**Keystone RV
Company**

RECREATIONAL SAFETY DEFECT SERVICE ADVISORY

Subject: Safety Recall: # 06V-053
Service Advisory: # 06-064

NRG Pull Down Bunk

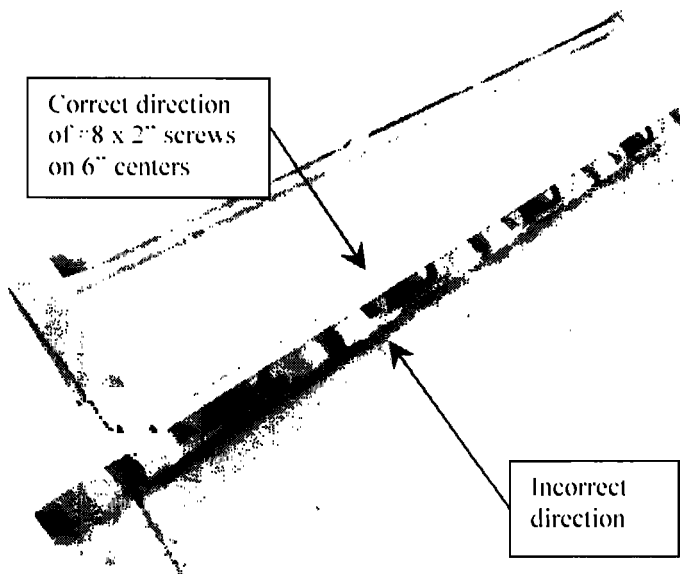
Step 1. Inspect the bunk bed platform. Check to see if the screws are installed from the platform side (interior of bed assembly) into the cloth covered rail every 6". Fasteners are incorrect if not installed this way.

- Step 4* Remove the gas struts from bed and remove bunk platform. Place the bunk platform on the floor.
- Step 5* Using #8 x 2" washer head screws, install screws from platform (interior) side of bunk into cloth covered rail every 6" on each side of bed platform. This is corrective action for Step 1 inspection.
- Step 6* Using #8 x 1-1/2 washer head screws, fasten guide channels to sidewall at a spacing of every 3". This is corrective action for Step 2 inspection.
- Step 7* Re-install bunk assembly by attaching gas struts; raise and lower bunk to check clearance in guide channel and proper function.

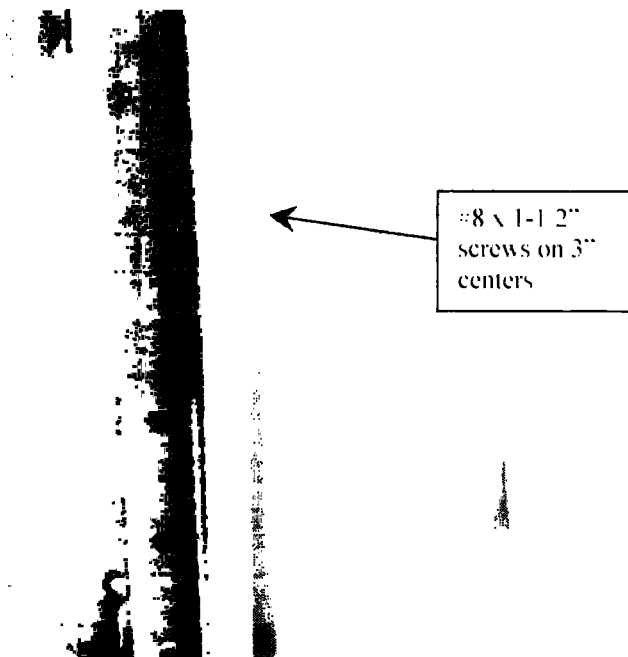
- Step 2.* Inspect the guide channels to see if screws attaching the guide to the wall were installed every 3". The picture below shows a guide mounted **WITHOUT** the required fasteners at 3" spacing.
